IFB NUMBER: IFB 26-024/MR
IFB TITLE: Jack Brooks Regional Airport Airfield Lighting Rehabilitation
IFB DUE BY: 11:00 am CT, Wednesday, June 17, 2026
ADDENDUM NO.: 3
ISSUED (DATE): June 10, 2026

ADDENDUM NO. 3

Date: June 10, 2026
Project Name: Airfield Lighting Rehabilitation Project
Owner: Jefferson County
Jack Brooks Regional Airport
Owner Project No: Jefferson County Project IFB 26-024/MR
Garver Project No: 2400880

CONSTRUCTION SAFETY & PHASING NOTES 1

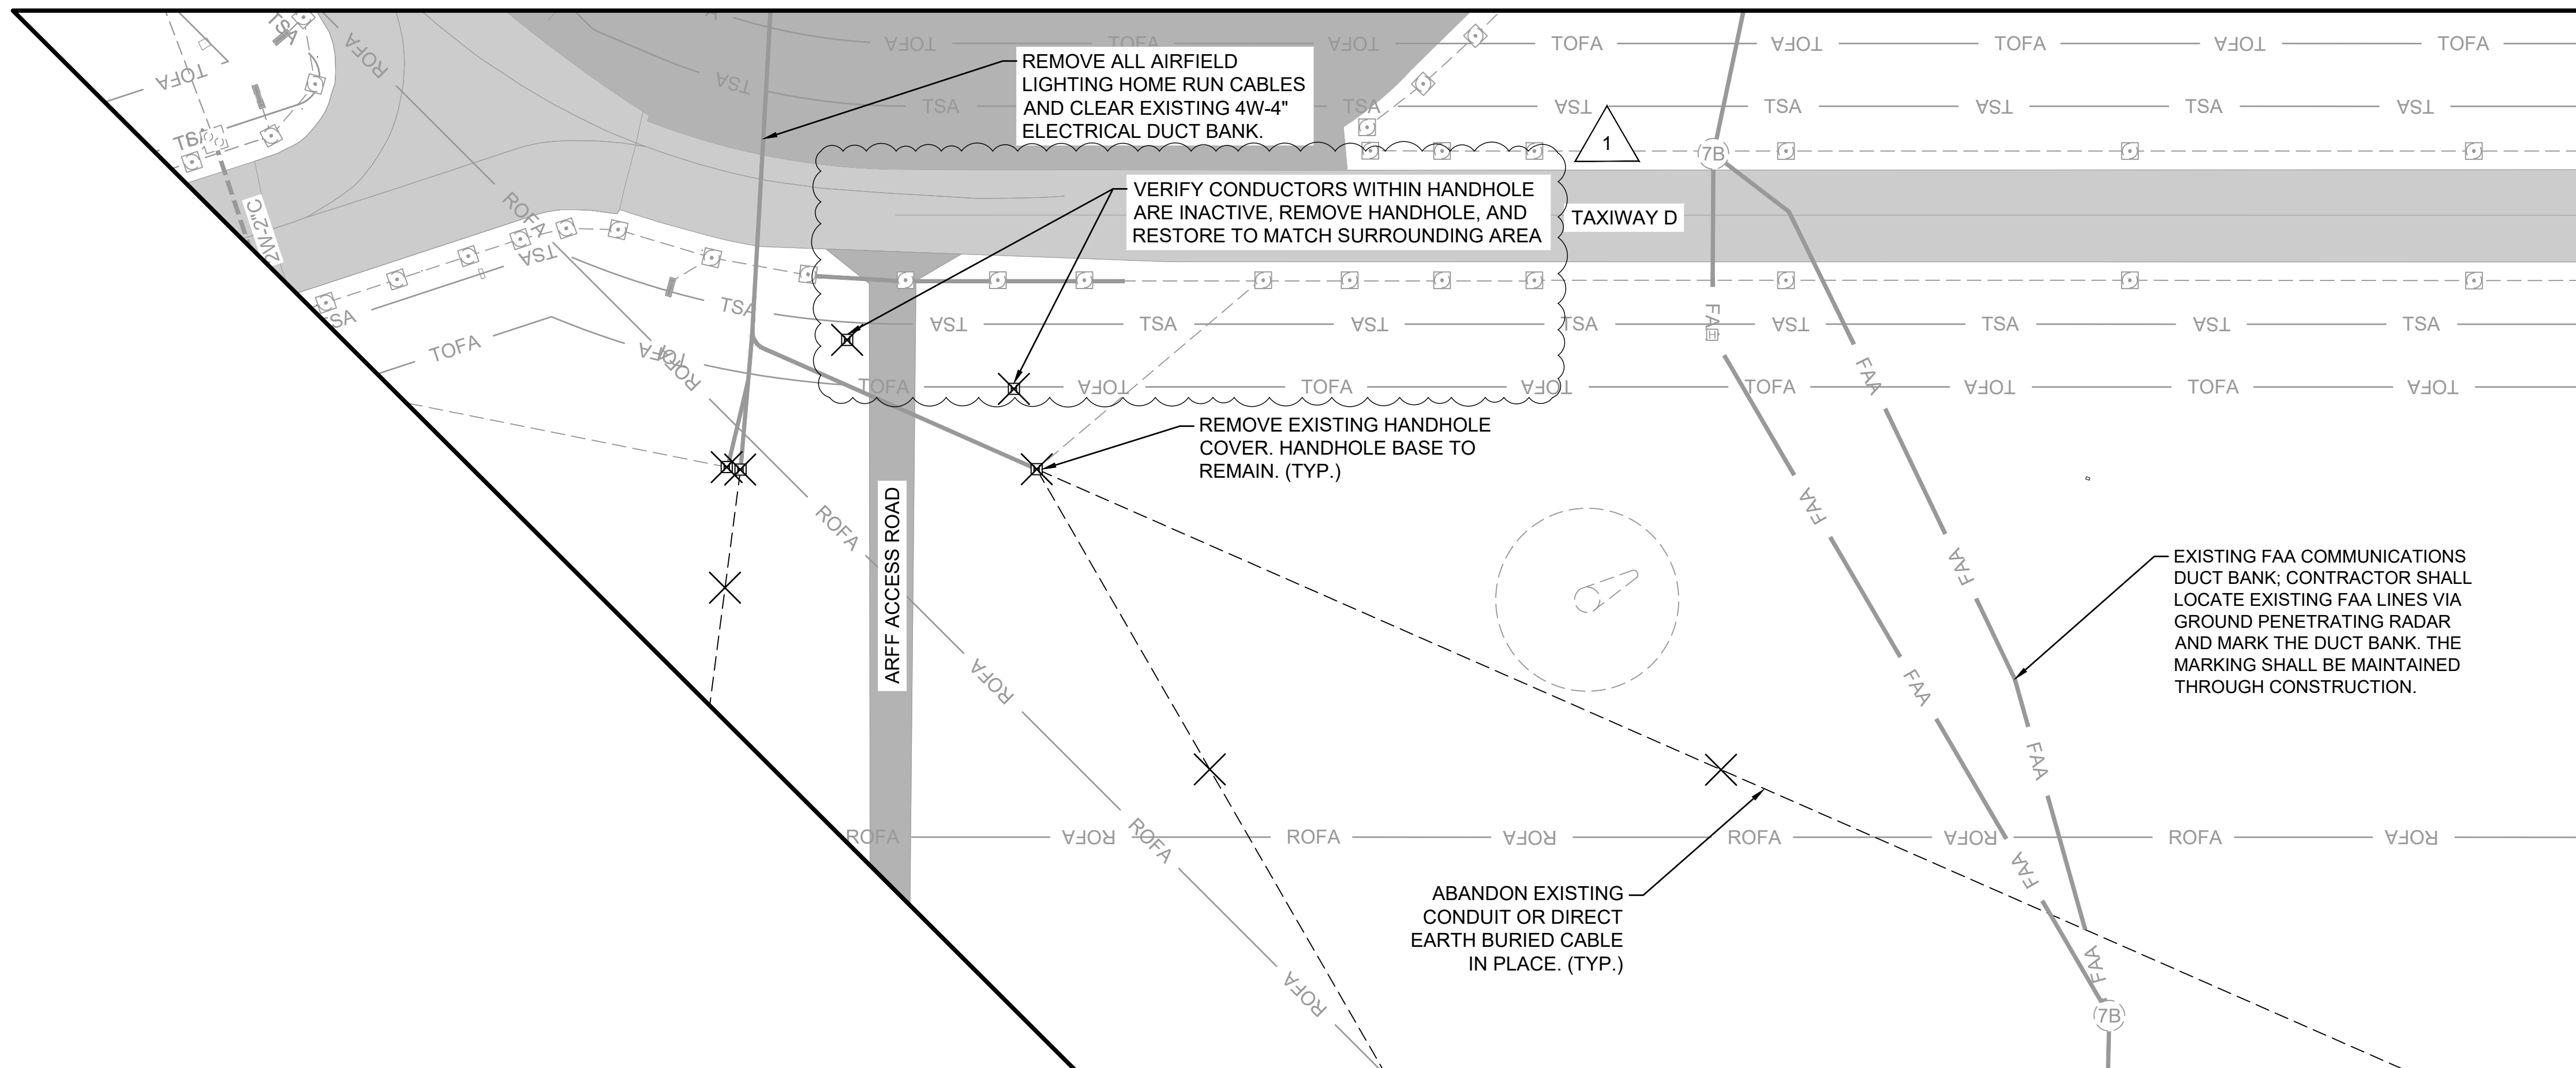
1. Remove the following drawings in their entirety, and replace with the same, attached hereto:
 - a. GC001 – Construction Safety & Phasing Notes 1
 - b. ED106 – Lighting Demolition Plan 6
 - c. EL507 – Lighting Installation Details 7

LIGHTING DEMOLITION PLAN 6

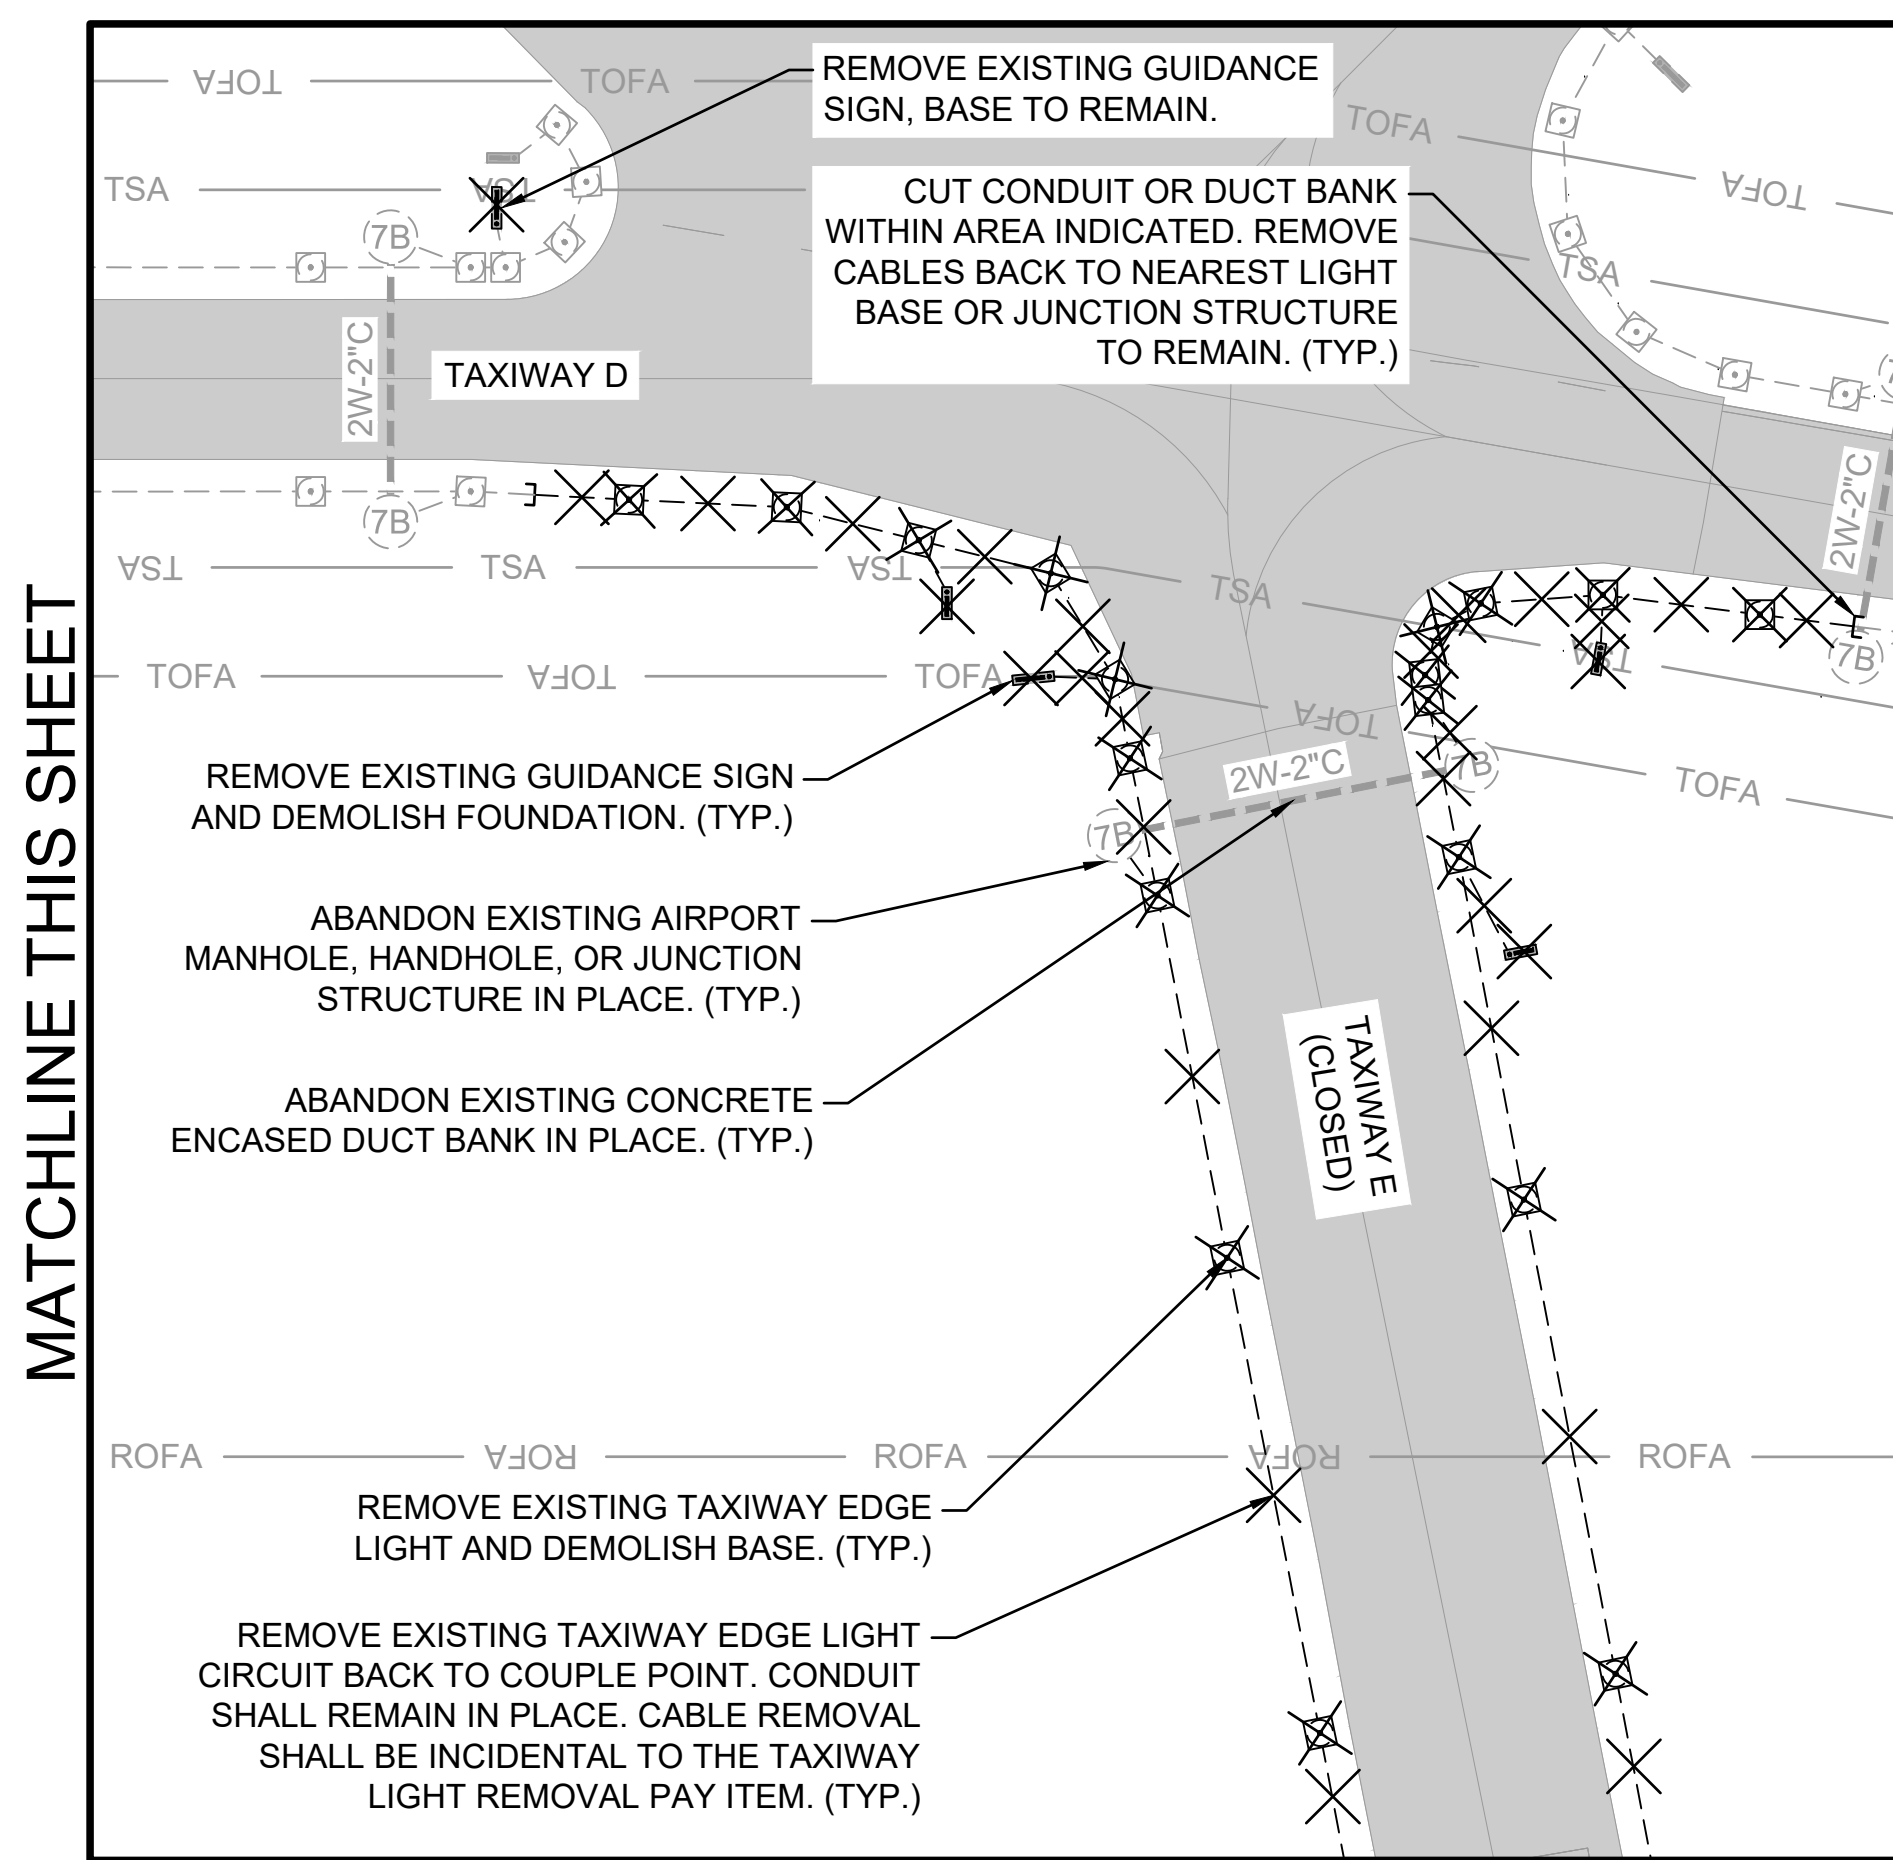
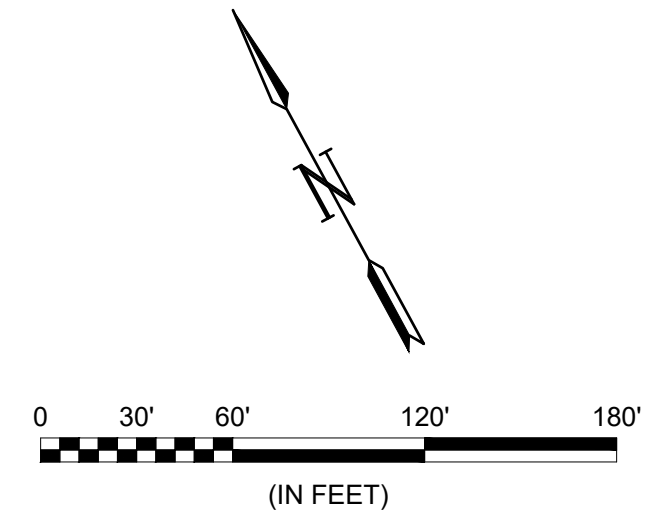
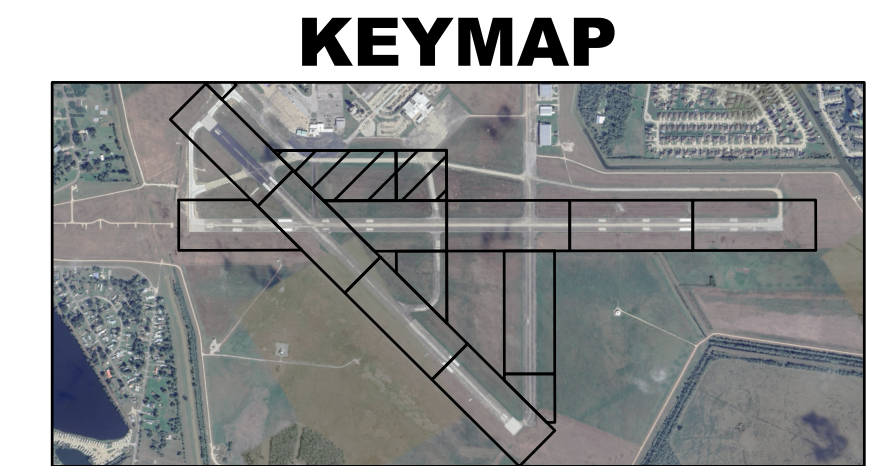
REV.	DATE	DESCRIPTION	BY
1	6/10/26	ADDENDUM NO. 3	MCL
